## **ADDENDUM NO. 2**

**PROJECT NAME: 2016-2017 TASK ORDER CONTRACT FOR FEDERALLY FUNDED  
PROJECTS PACKAGE 2 – 23-01429**

DATE: 9/8/2015

CONCRETE SIDEWALK SECTION

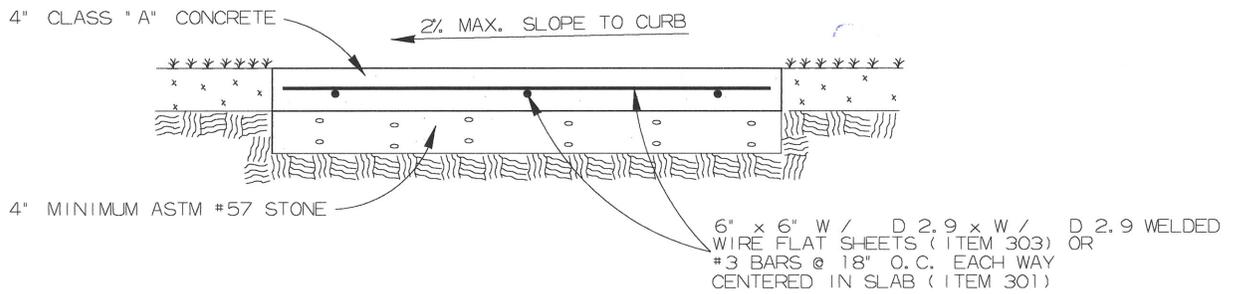
- b. SUP Spec 11 – ASTM 57 Stone for Concrete Sidewalks
- c. ASTM 57 Stone for Concrete Sidewalks Detail

THIS BASE SECTION SHALL BE USED IN LIEU OF FLEXIBLE BASE ON A CASE BY CASE BASIS AND AT THE DISCRETION OF THE ENGINEER OR PROJECT MANAGER. FOR PROJECTS THAT REQUIRE ASTM #57 STONE BASE, THE 2" FLEXIBLE BASE SECTION WILL BE OMITTED. PAYMENT FOR ASTM #57 STONE WILL BE PAID IN A SQUARE YARD BASIS UNDER THE CONTRACT BID ITEM.
